## 6 Key Changes from 2017 consented scheme

The items listed below describe the main changes proposed from the consented scheme. For a full list of changes, which include very minor amendments to the layouts, refer to “Schedule of Changes Post Consent” and BDP drawings series (15) and (31) included in section 7 of this report.

### 6.2 REDUCED NUMBER OF FAN COIL UNITS

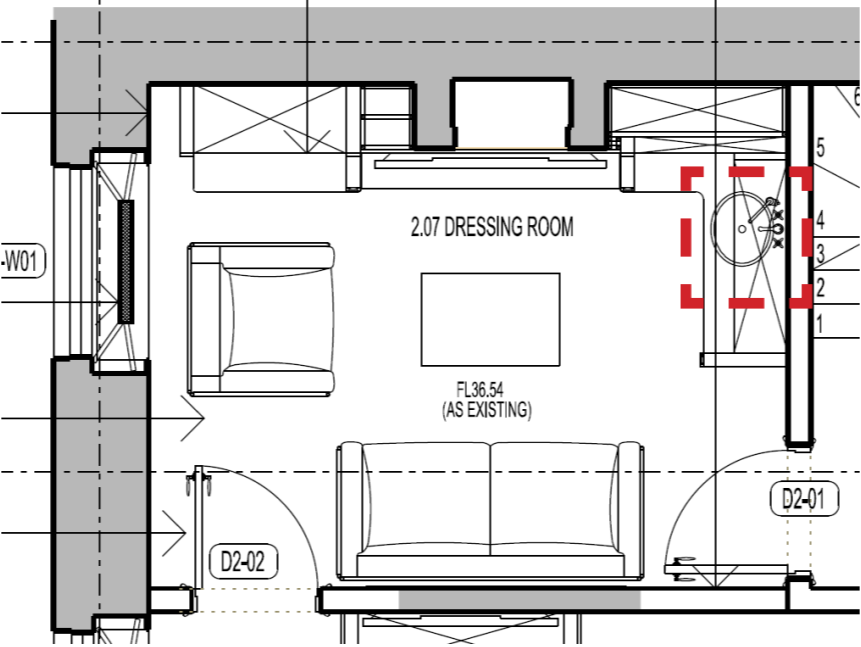
The Design Team have successfully reduced the number of required Fan Coil Units from 22 to 17.

New reduced size FCU's will be located within fixed joinery units as per the consented scheme.

This has also allowed the Design Team to reduce the number of required fixed furniture elements thus reducing the necessary fixings to existing walls. The fan coil units are as noted in the proposed General Arrangement plans BDP (15) Series.

The location of the remaining FCU's are unchanged from the consented scheme.

### 6.5 STRUCTURAL ENGINEER DETAILS

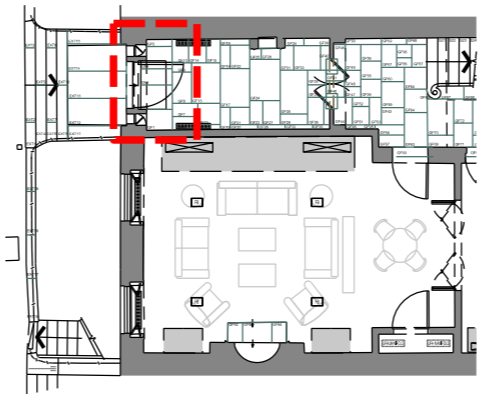
Structural Engineer details have been developed to resolve the concern over support to the Main staircase at ground floor level. The detail was agreed with the Conservation Officer during a site visit in October.

The proposed detail will be located to the underside of the main stair on Lower Ground Floor level, away from view and will not impact the value of the Main Entrance Hall.

The plate has been designed so that the fixing into the party wall can be flush with the plate. The plate into the party wall is to sit on the brickwork so that the plaster finish can cover the plate. This will require making good of the plaster.

Details to discreetly cover this detail will be developed with the Interior Design Team members. See image below noting the proposed location for the support angle. The proposed Structural Engineer detail is provided on the next page. Note the timber post seen in the below photograph is assumed to have been added in the early part of the 20th century.

6.6 PROPOSED MAT WELL

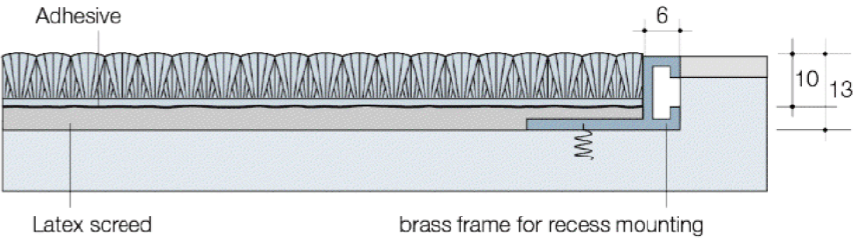
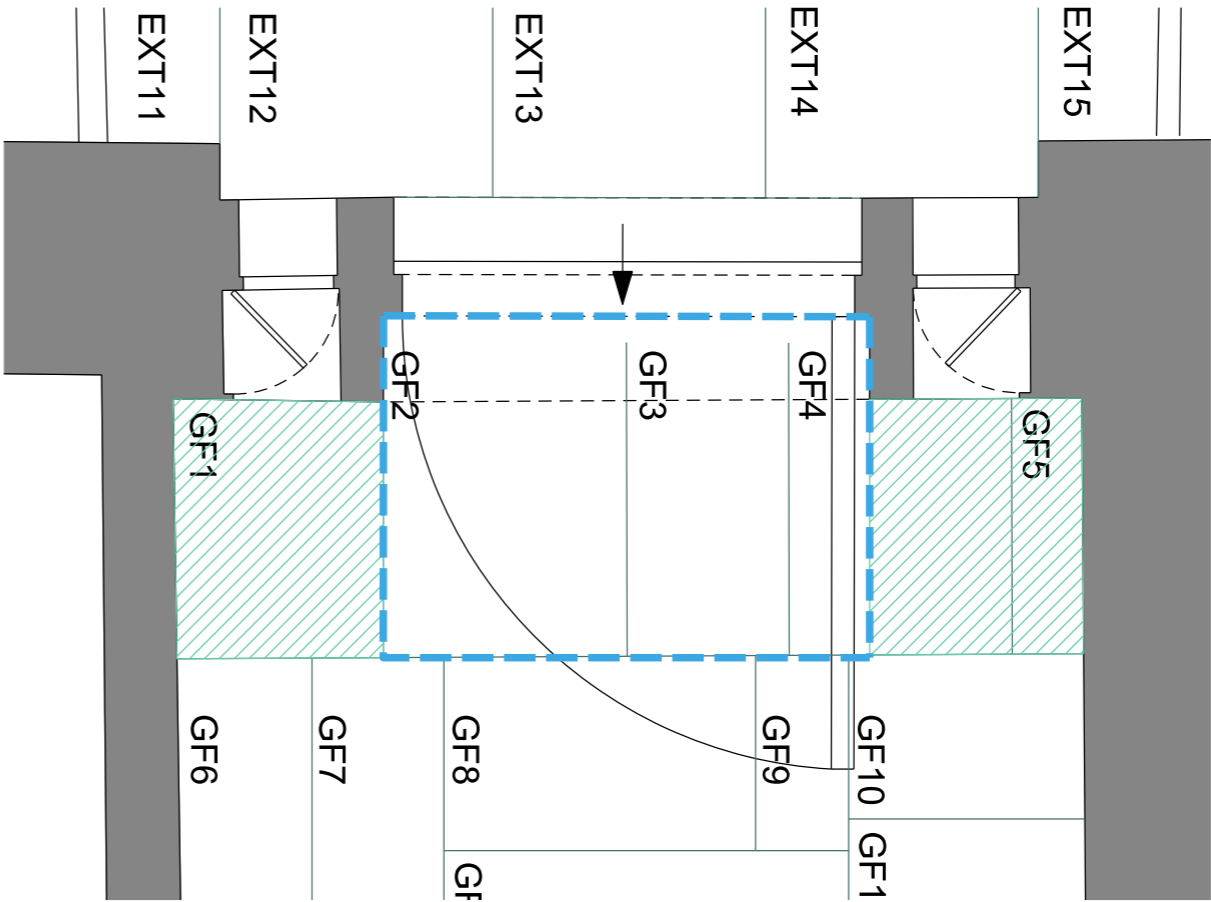
It is proposed to incorporate a recessed mat well to the Main Entrance Hall on Ground Floor level. The stone to the entrance threshold was previously removed and would need to be replaced.

It is proposed to insert a recessed mat well with a brass frame border and replace stone to either side as required. As the historic stone had already been lost, this is considered to be of low impact as the action is reversible and stone could be inserted in the future.

Please refer to images below. The red dashed line indicates the extent of the proposed recessed mat well in context of the entrance hall, both from an internal and external viewpoint.

The space between the underside of the door and the finished floor level is not enough to have a surface mounted coir mat without undercutting the door which would have had more impact on the historic fabric .

- OUTLINE OF PROPOSED RECESSED MATT
- MISSING STONE TO BE REPLACED

## 6.7 UPGRADING OF EXISTING DOORS

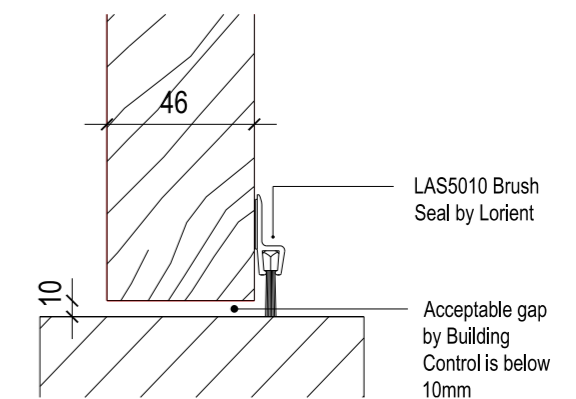
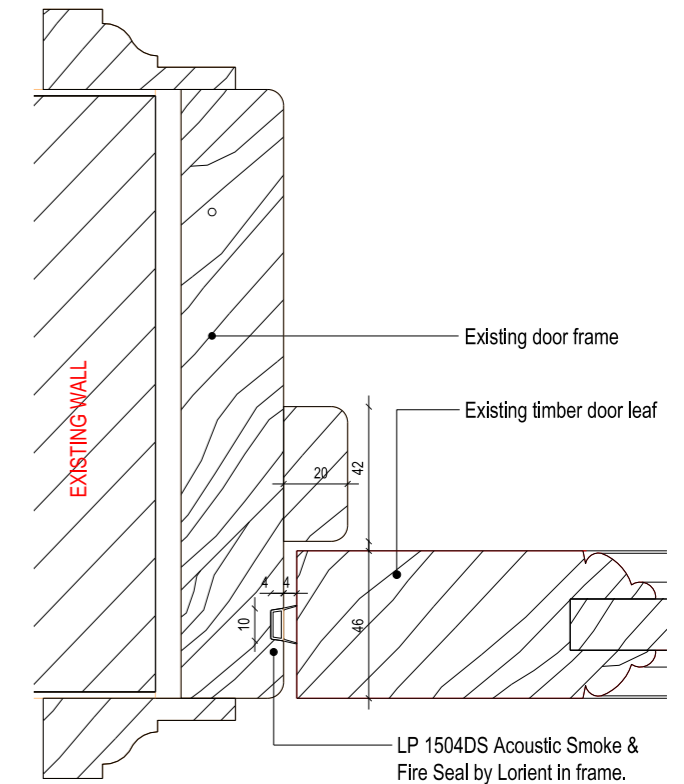
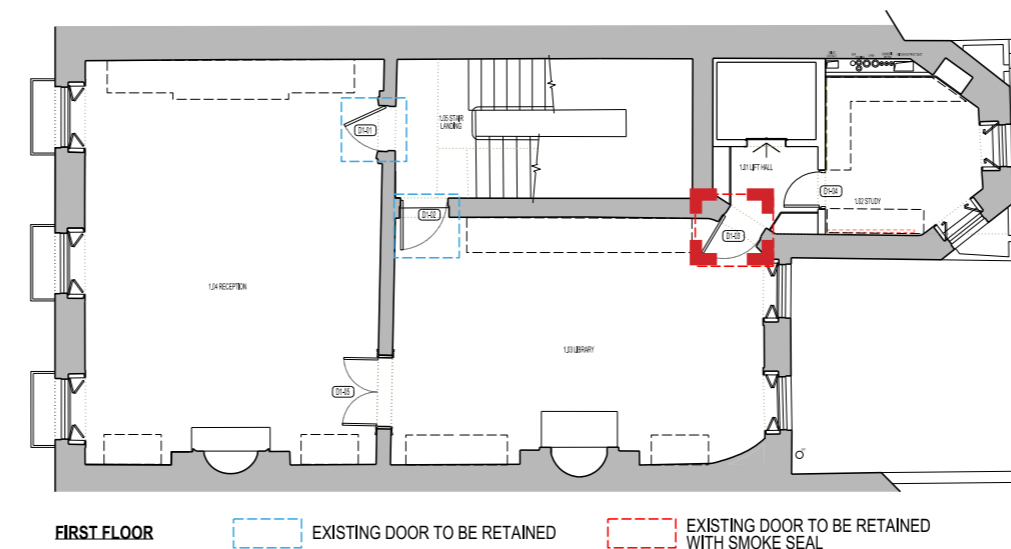
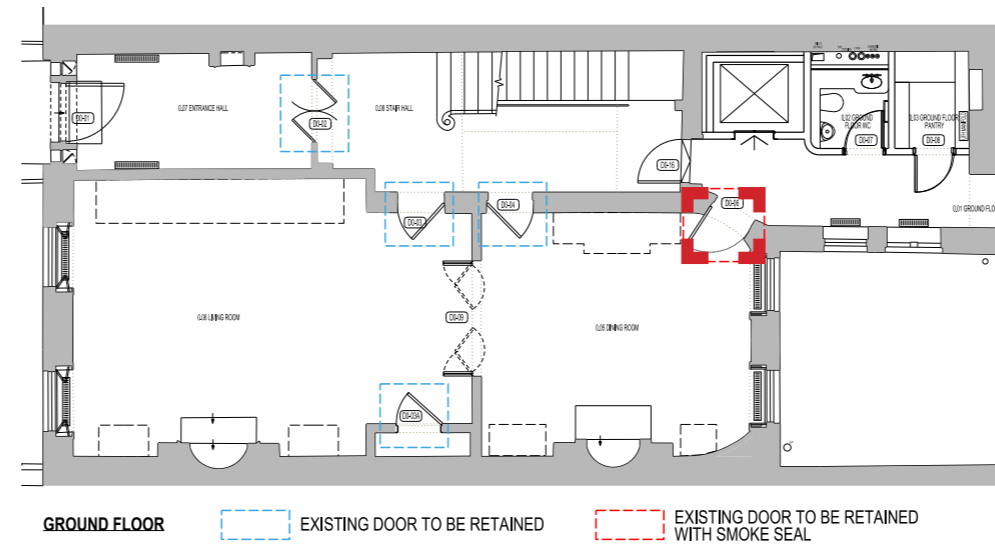
Following a meeting with BDP and Building Control, we can confirm that only 2 out of 8 existing doors need to be upgraded.

These two doors are D0-06 on Ground Floor and D1-03 on First Floor.

They both require a smoke seal which will require an intumescent seal fitted into the frame.

A 10mm (maximum) gap between door threshold and floor level is acceptable for ALL doors. Where the gap exceeds 10mm, it is proposed that a face mounted brush seal be used on existing doors to provide the fire resistance required.

This will need to be further assessed on site when floor finish levels are developed to confirm what existing doors require a brush seal.

BRUSH SEAL REQUIRED WHERE GAP BETWEEN FINISHED FLOOR LEVEL & BASE OF DOOR IS MORE THAN 10MM

6.8 REMOVAL OF BIFOLDING DOORS

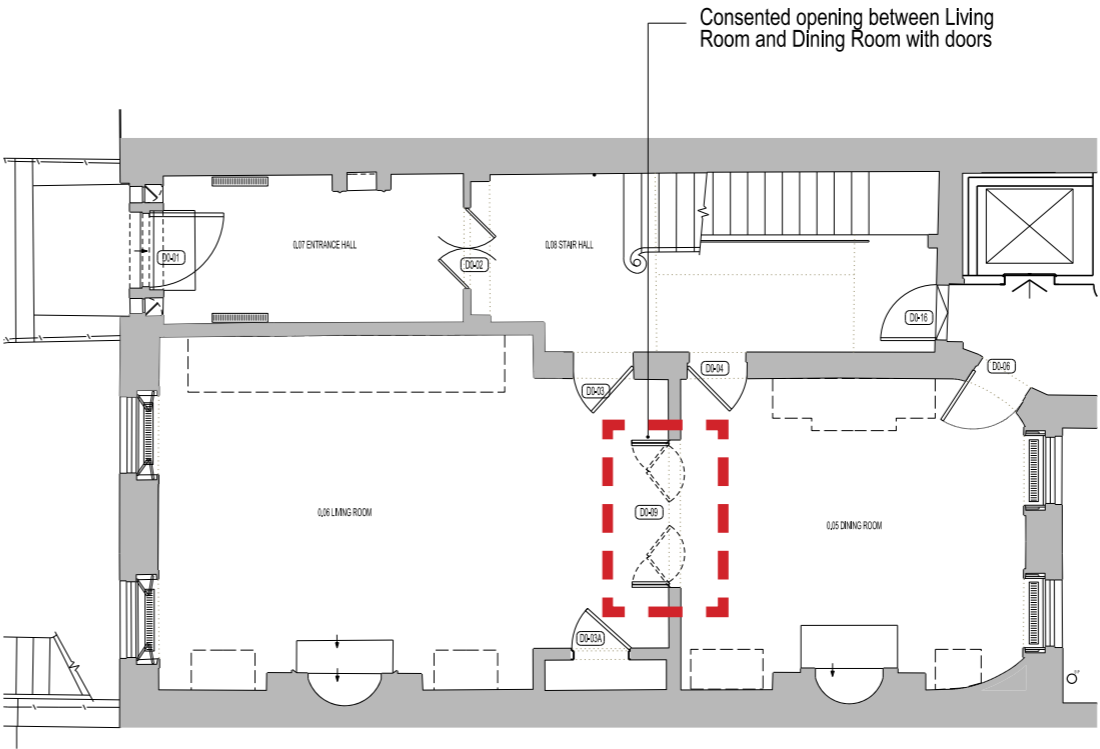
The proposal to not install the bifolding doors between the Family Room and Dining Room was discussed during a meeting with the Conservation Officer. The intention is to connect both primary spaces whilst retaining an modest opening within the wall.

The architrave will be reinstated similar to that shown in the image below. Typical moulding and architrave details will be submitted separately from this application reference Condition 5 of LBC Ref:2017/6975/L. This proposal is considered to be of low impact as the bi folding doors would be new and can be installed in the future.

## 6.9 LOWER GROUND FLOOR SHUTTER REMOVAL

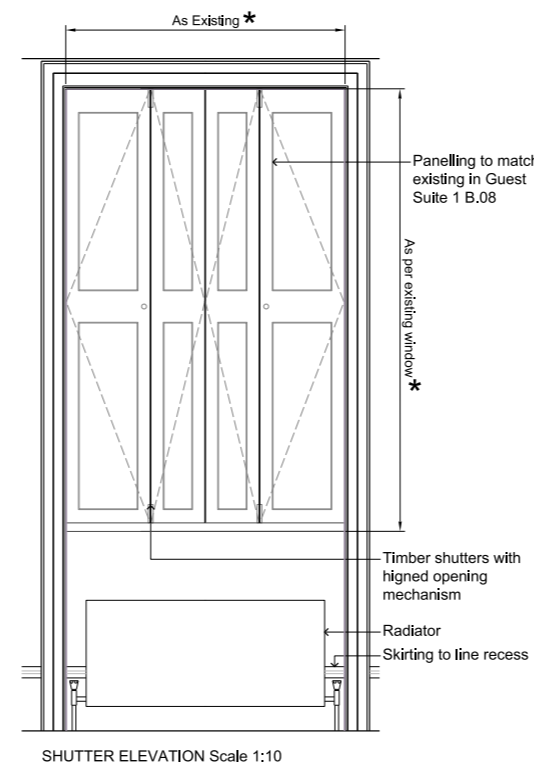
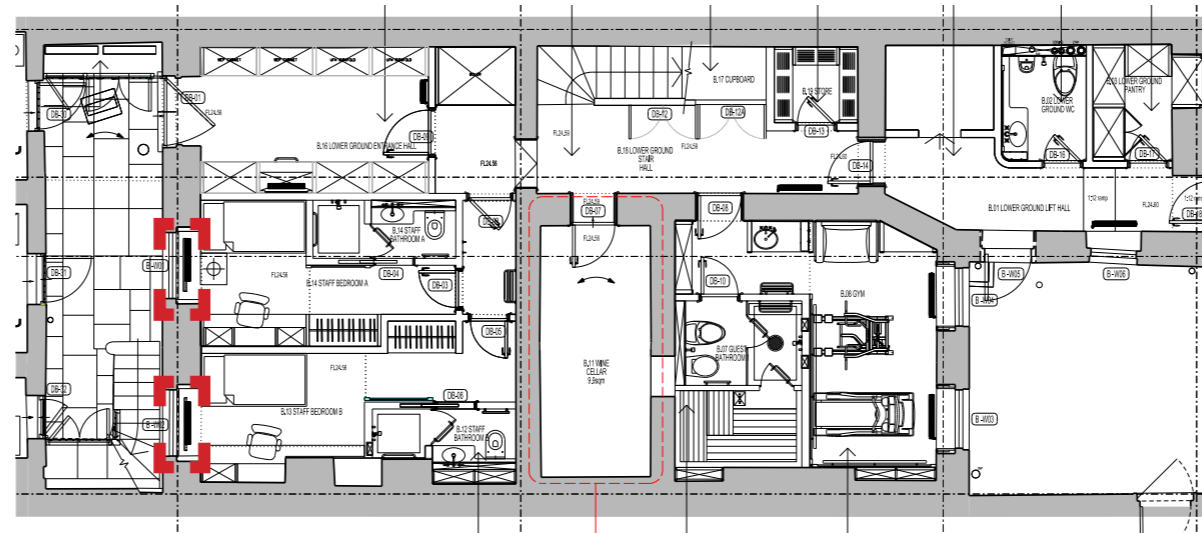
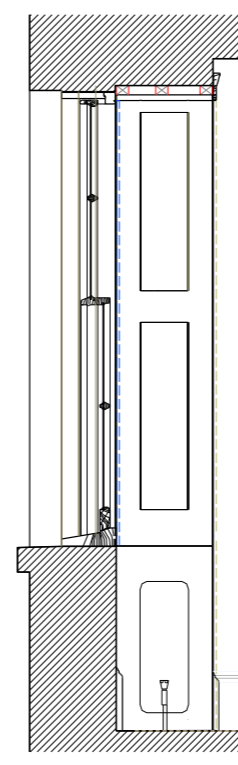
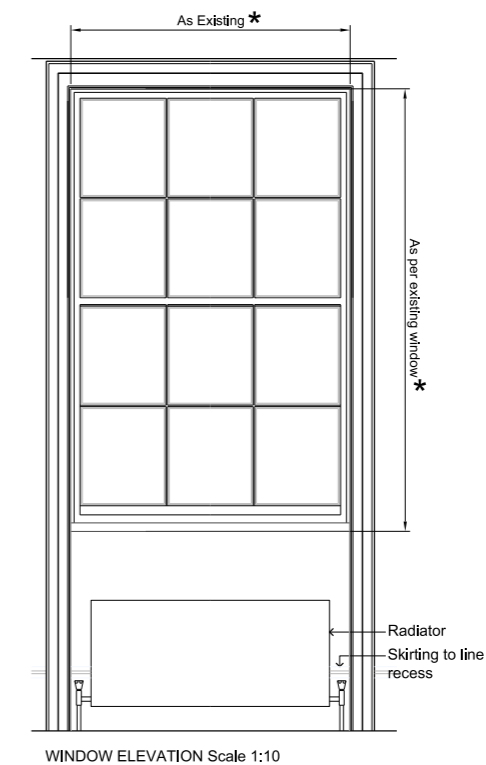
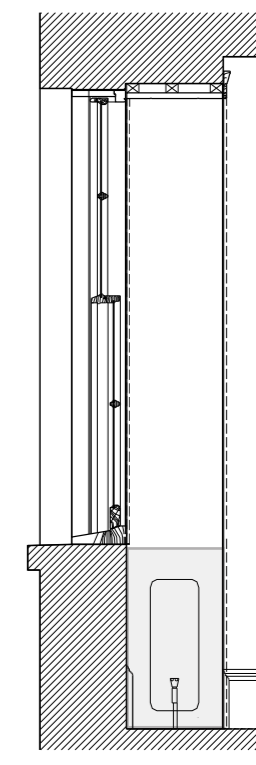
When the lower ground floor shutters within the two windows to the front elevation were removed, they were found to be MDF and non original, (thought to have been installed in the 1980s). Given this discovery It was agreed that shutters do not need to be reinstated in this location following a site visit by the Conservation Officer.

The drawing shows the low impact of the removed shutters. The rooms will act as staff accommodation. Alternative discreet privacy/screening proposals will be developed by the Interior Design Team.
